Register Reference: Development:	SD22A/0128 AI Amendment to Block D2, located towards the south-eastern corner of the site located north of Scholarstown Road called 'Two Oaks', formally incorporating dwellings known as 'Beech Park' and 'Maryfield (657sq.m) of the scheme granted under ABP Ref: 305878-19 and the non-material amendments permitted under ABP Ref: 311752-21; Block D2 as granted provided two retail units at ground floor level measuring 135sq.m and 112sq.m and a restaurant/cafe at first floor level measuring 271.5sq.m; The amendment proposes the provision of a single retail unit in Block D2 comprising the amalgamation of the two permitted ground floor units and the change of use of the first-floor unit from restaurant/cafe to ancillary retail floor area principally providing storage/back-of-house/office space for the retail unit at ground floor level; and all associated works. Retention permission is sought for minor elevational changes to Block D2.

Location:	Site at Scholarstown Road, Rathfarnham, Dublin 16
Applicant:	Ardstone Homes Limited
App. Type:	Permission and Retention
Planning Officer:	CAITLIN O'SHEA
Date Recd:	
Decision Due Date:

Roads Department – Planning Rep

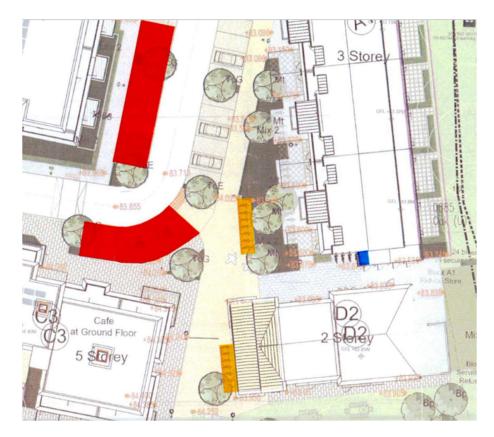
2. Considering the proposed amalgamation of the units in Block D2, and the potential increase in traffic generation, the car parking ratio for the development as a whole must be carefully considered. The applicant is requested to submit a car parking rationale including calculations used, and, if applicable, a revised car parking drawing.

Within the original application, a total of 30 car parking spaces were allocated specifically to Block D2. This was due to the requirement to provide parking spaces for two separate retail units as well as a café/restaurant. This was also considered a conservative provision and complied with the maximum parking guidance from the SDCC development plan.

The proposed amendments to Block D2 comprise of the amalgamation of the two separate retail units into one retail unit and the removal of the café/restaurant which is being replaced in its entirety by back-of-house/ancillary

Roads Department is satisfied with the applicant's submitted documents which explain in the required detail that the 12no parking spaces and 30 (28+2) cycle parking spaces will suffice in providing adequate parking to this retail unit.
